FLAT CREEK ADDITION

WICHITA, SEDGWICK COUNTY, KANSAS

RE: SUB 2001-28 -- Revised One-Step Final Plat of Flat Creek Addition

RE: SUB 2001-28 - One-Step Final Plat of Flat Creek Addition

FLAT CREEK ADDITION

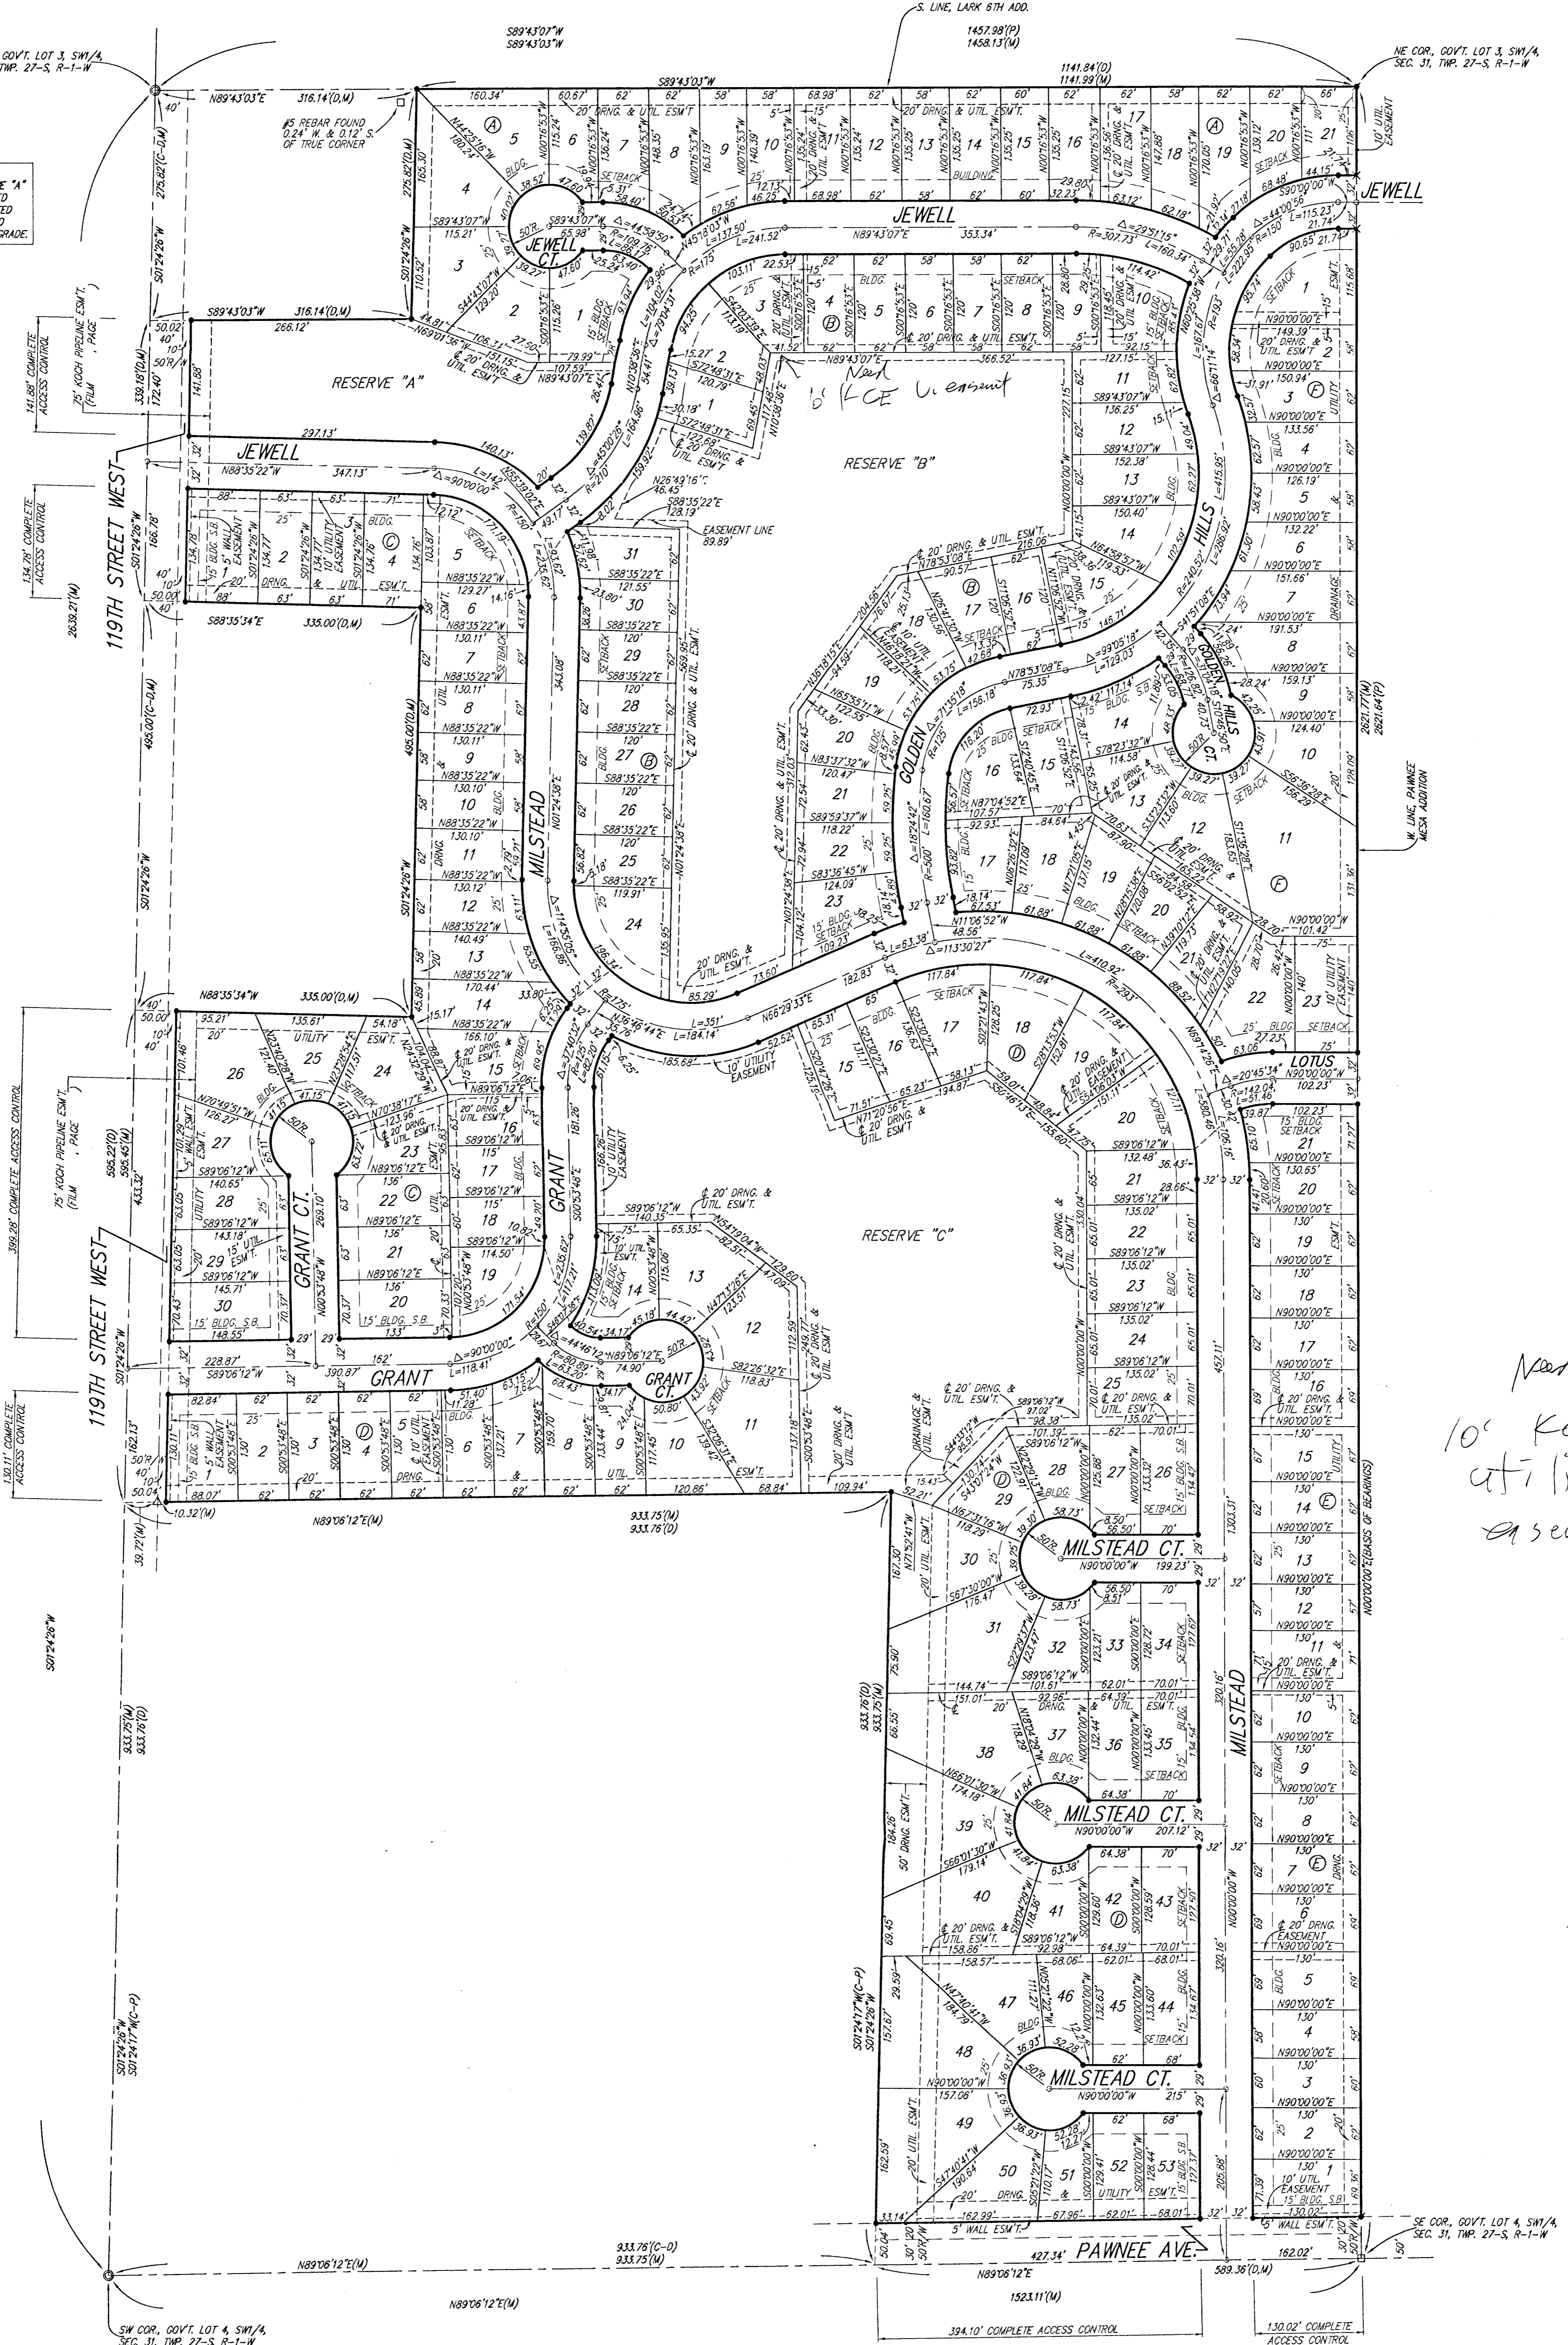
*Need
10' KEEP
utility
easement*

- J. It appears that the width of the through street and loop streets are measured as 64 feet although incorrectly labelled as 70 feet.
- K. Lots 7, 8 and 11, Block F, exceed the maximum lot width to lot depth ratio of 2.5 to 1. *A modification has been approved by the Subdivision Committee.*

- X. The representatives from the utility companies should be prepared to comment on the need for any additional utility easements to be platted on this property. **KGE has requested additional easements.**
